# UNITED STATES PATENT AND TRADEMARK OFFICE

APPLICATION NO.	FILING DATE	FIRST NAMED INVENTOR	ATTORNEY DOCKET NO.	CONFIRMATION NO.
09/942,939	08/31/2001	Min Seok Oh	P-0261	8961
34610	7590	10/07/2005	EXAMINER	
FLESHNER & KIM, LLP P.O. BOX 221200 CHANTILLY, VA 20153			LAMARRE, GUY J	
			ART UNIT	PAPER NUMBER
			2133	
DATE MAILED: 10/07/2005

## Office Action Summary

**FIG. 1**  
CONVENTIONAL ART

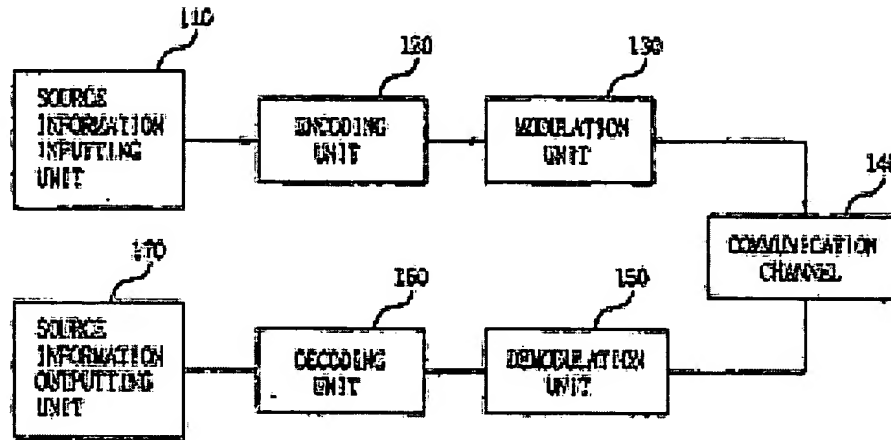
As per **Claims 1-3, 5-8, 11-13, 16 and 17**, **Admitted prior art** substantially discloses the claimed RS coding conversion means, in **Admitted prior** Fig. 1, comprising: encoding/decoding/trellis processing/modulation/demodulation means as seen in **Admitted prior** Fig. 1, and means for

generating binary equivalence of the code by multiplying systematic generator matrix (Fig. 2 for matrix representation) and binary information sequence of the code; and generating row and column vectors (Fig. 2 for matrix representation) using the binary equivalence of the code as a component code. {See **Admitted prior art** Figs. 1-2, and related description.}

**Not specifically described** in detail in **Admitted prior art** is the step whereby the code is Reed-Solomon or non-binary.
